Amendment Notice 1

Licence Number L7026/1997/14

Licence Holder Shire of Plantagenet

Mount Barker Waste Management Facility
O' Neill Road
Shire of Plantagenet
MOUNT BARKER WA 6330

FIGURE E7029/1007/17

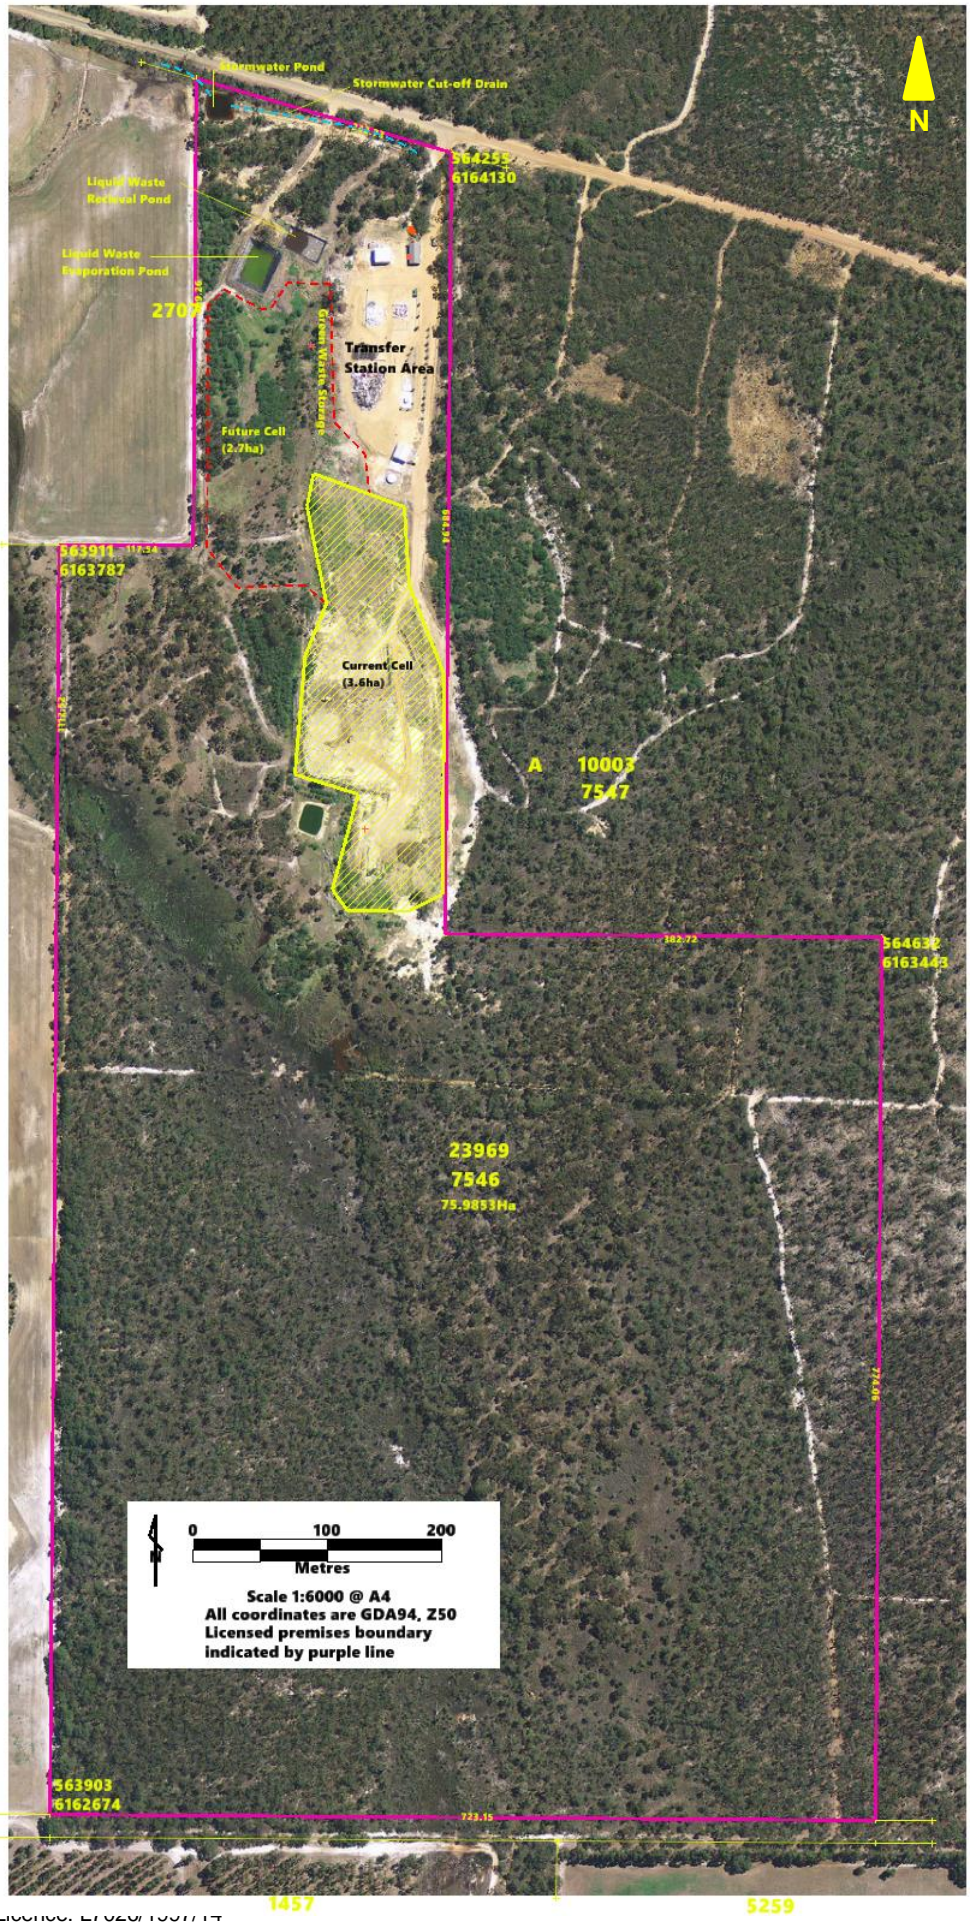
- Front page: Increase to Category 61 approved premises production or design capacity; and
- Condition 1.2.2, Table 1.2.1, Quantity limit; and
- Condition 1.2.6, Table 1.2.4, 'Containment infrastructure'; and
- Schedule 1: Maps – Map of storage locations.

6. The Licence is amended with the replacement of Schedule 1: Maps – ‘Map of storage locations’ with the map shown over:
